IN THE DRAWINGS

HELMET

Appl'n No: 10/614,995

ANNOTATED
MARKED UP DRAWINGS

FIG. 3

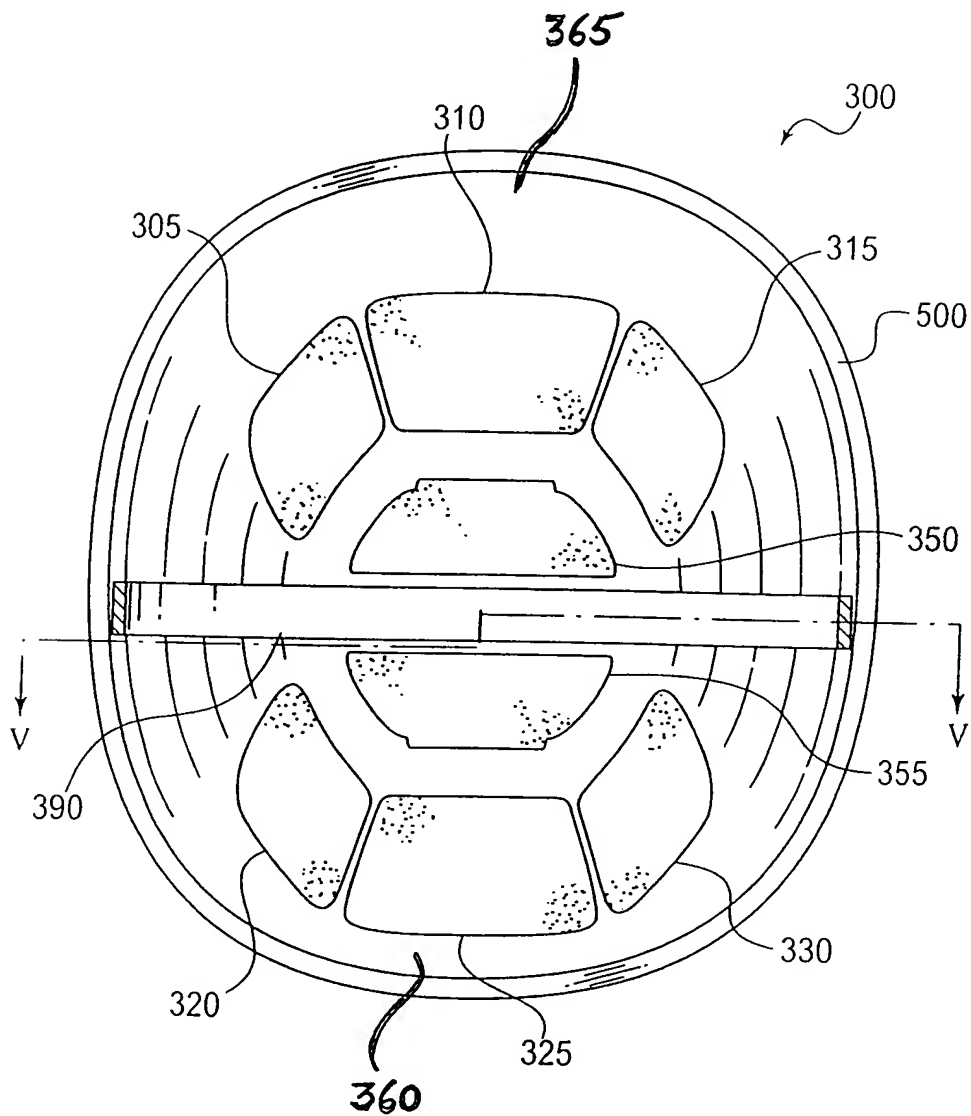
Figures 3 and 5 have been amended, in red ink, and are attached to this amendment for the Examiner's approval. In particular, applicant has added reference numerals to the corresponding Figures to describe existing portions of the helmet and pad set of the invention. No new matter has been introduced by the amendment.

Applicant submits herewith some specification corrections in response to the Examiner's objection to the same. In addition, some amendments to Figures 3 and 5 in support of the specification amendments have also been made, in red ink, for the Examiner's review. Applicant submits replacement sheets of drawings with the proposed changes as an appendix to this response. No new matter has been added by these amendments. Accordingly, reconsideration of the rejection is respectfully requested.
